MWO 9-1005-201-30-6

MODIFICATION WORK ORDER

**MODIFICATION OF MACHINE GUN, 5.56MM, M249
(NSN 1005-01-127-7510) (EIC: 4BG) Automatic Rifle Role
(NSN 1005-01-451-6769) (EIC: 4BK) Light MG Role**

15 August 2005

Figure 1

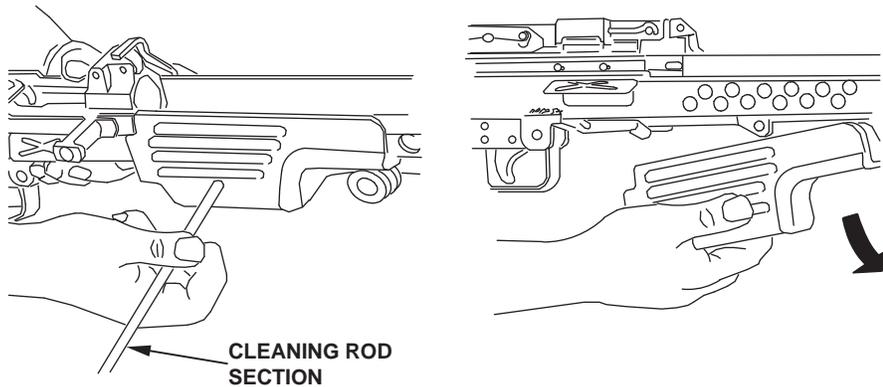
- (2) (Figure 1) Remove the handguard by pushing handguard retaining pin to the left using a cleaning rod section, then remove handguard downward.

Figure 2

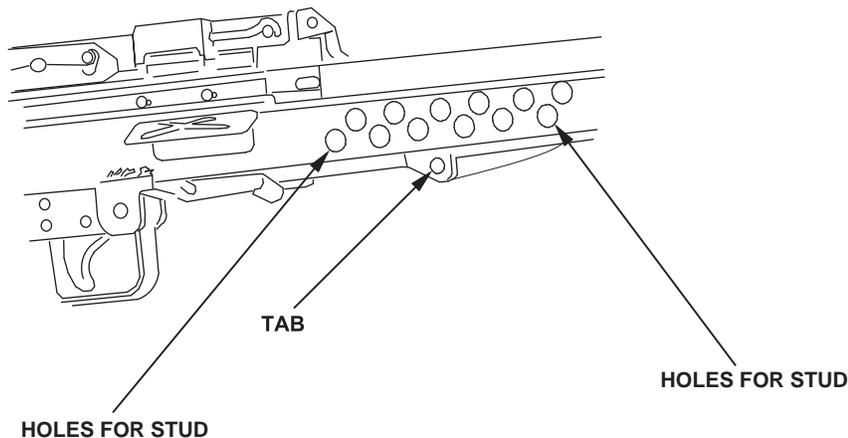
- (3) (Figure 2) Install the right adapter rail (the one with two rails) on the right side of the receiver. This rail has a relief cut for the tab located on the bottom of the receiver to allow the rail to fit flush against the bottom of the receiver, and also allows the two studs to fit into the holes on the side of the receiver.

Figure 3

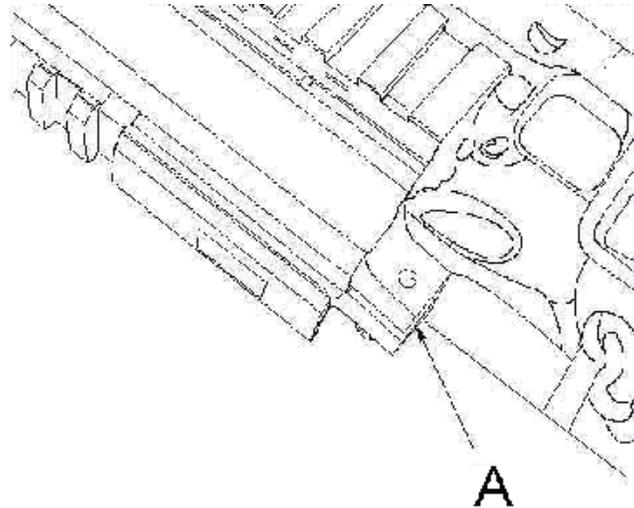
(4) (Figure 3) Install the left side adapter rail so the adapter fits on the bottom of the receiver and ends of the two adapter rails are aligning with each other. The two studs will also fit into the holes on the side of the receiver. Illustration above shows that the rails should be flush against the bottom of the receiver (A).

Figure 4

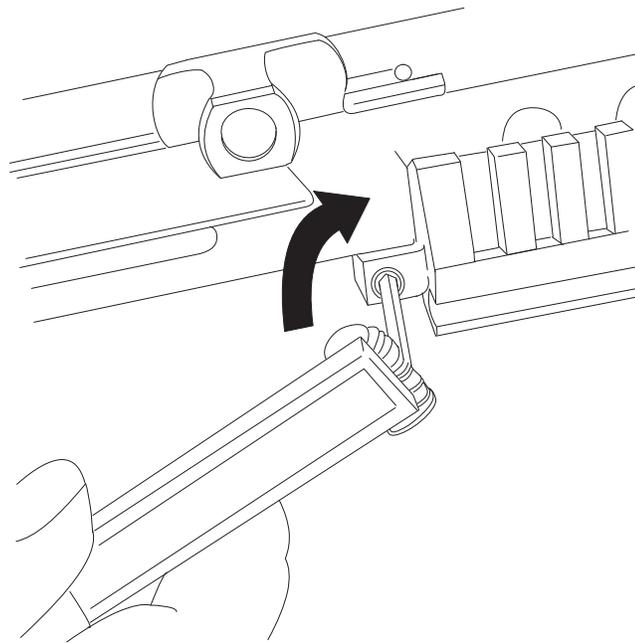
(5) (Figure 4) Using a 9/64 hex key wrench, install the two screws (one at each end of the adapter rail) from the right side of the adapter rail and tighten snug. Do not over tighten.

Figure 5

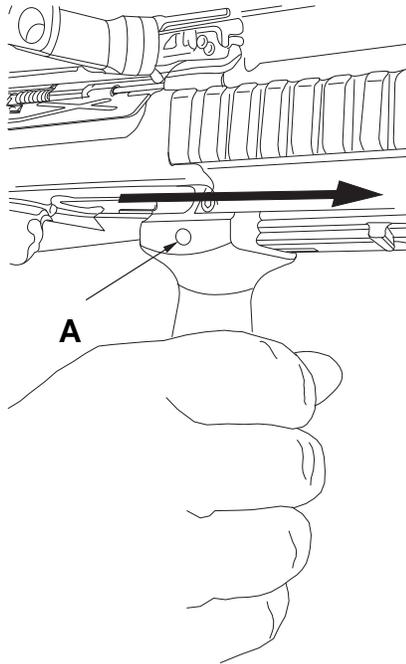
(7) (Figure 5) Install the vertical pistol grip on the bottom rail by sliding it from the rear to the front until the locking lug of the vertical pistol grip lines up with a slot on the adapter rail. Adjust accordingly to the length of the operator's arm. View rail slot through hole in vertical pistol grip (A).

Figure 6

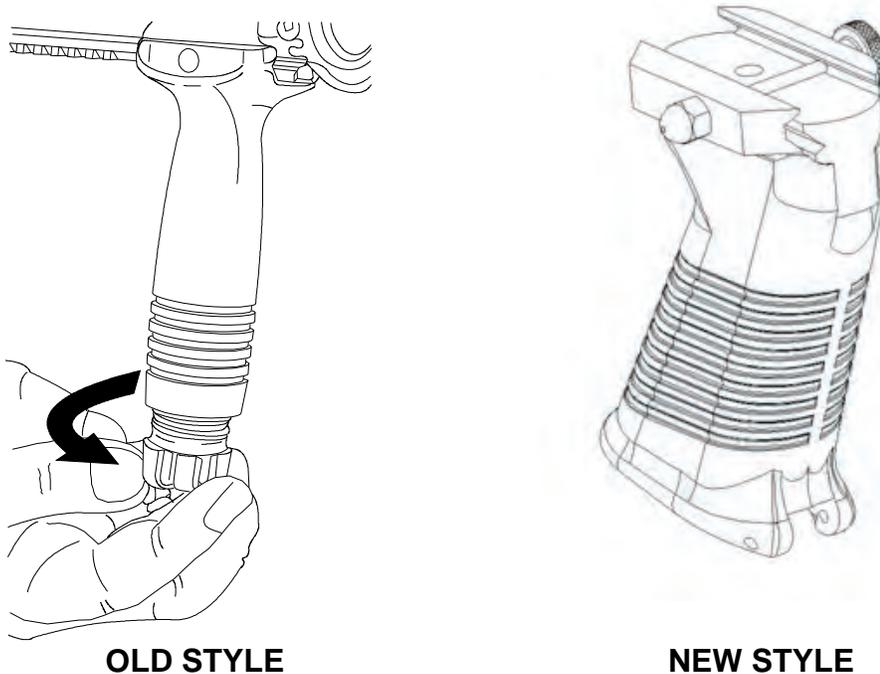
(8) (Figure 6) Tighten the O-ring clutch on the bottom of the vertical pistol grip by turning the clutch to the right.

Figure 7

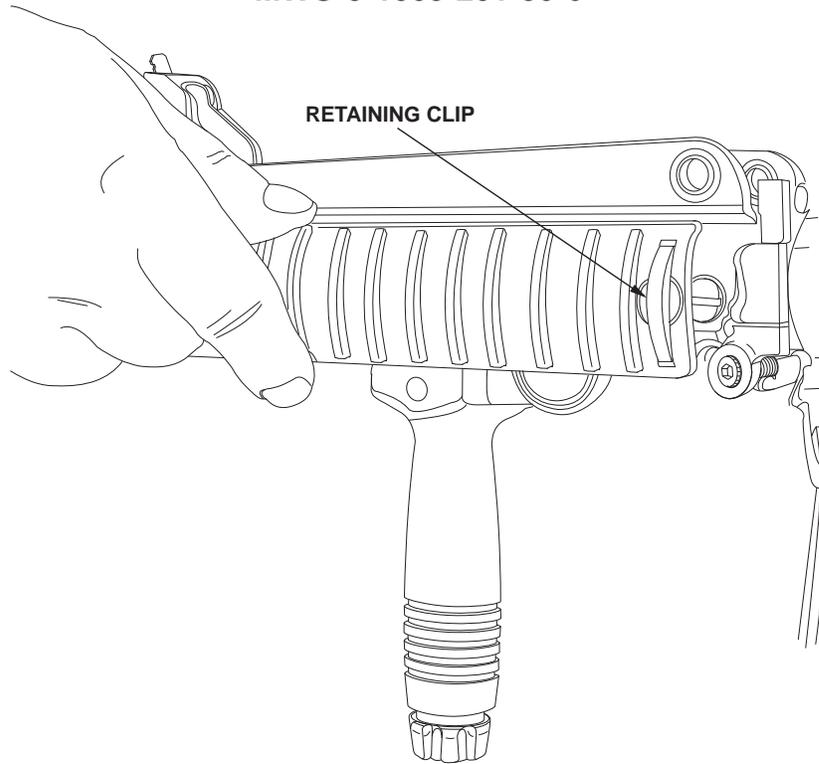
(Figure 7) Rail covers are quickly attached and detached from the adapter rail. A retaining clip at one end of each rail cover automatically engages cutouts positioned at either end of the three rail sections. To slide a rail cover beyond a cutout, or to remove it, slide it in the desired direction while applying thumb pressure to the retaining clip. Illustration above shows rail cover in full rearward position.

(9) (Figure 7) To cover both side rail surfaces, install the rail covers from the muzzle end of the adapter rail with the retaining clip forward. To cover the bottom rail surface, install from the rear with the retaining clip forward.

Figure 8

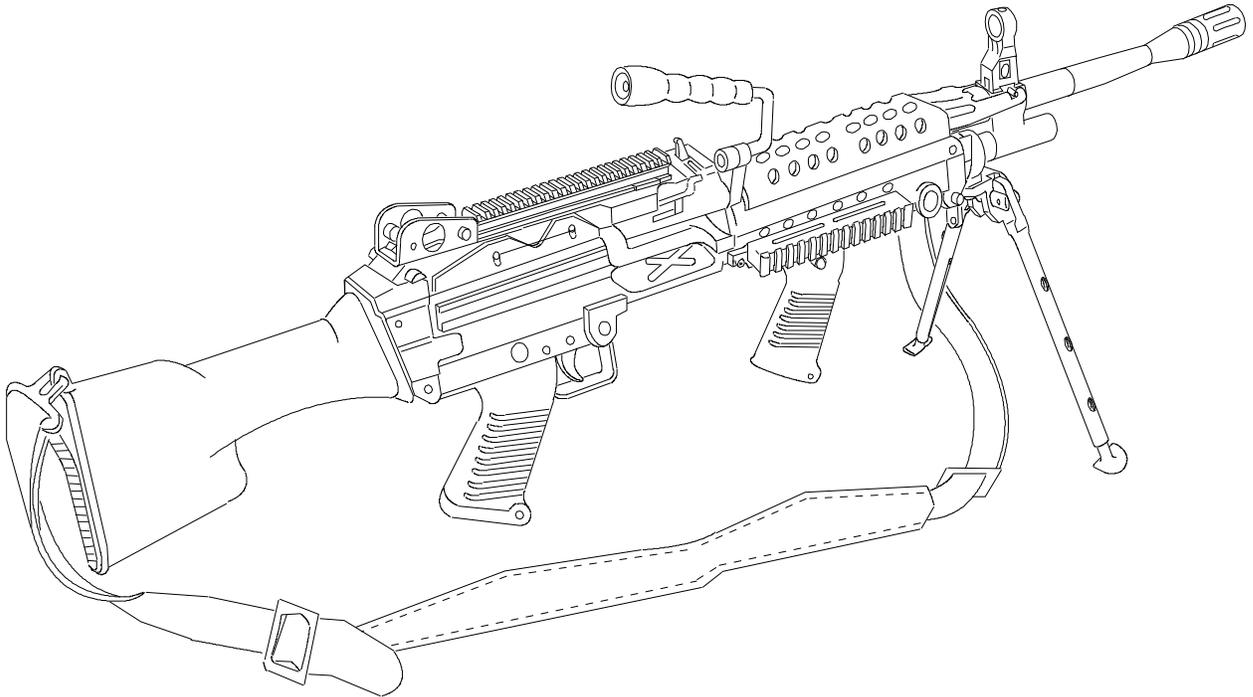
16. MODIFICATION IDENTIFICATION. No change in NSN, nomenclature, LIN or model designator is made by this MWO. The application can be verified by visual examination of the receiver assembly for a MIL-STD-1913 Rail. See Figure 8 below for illustration of the M249 MG after completion of this MWO.
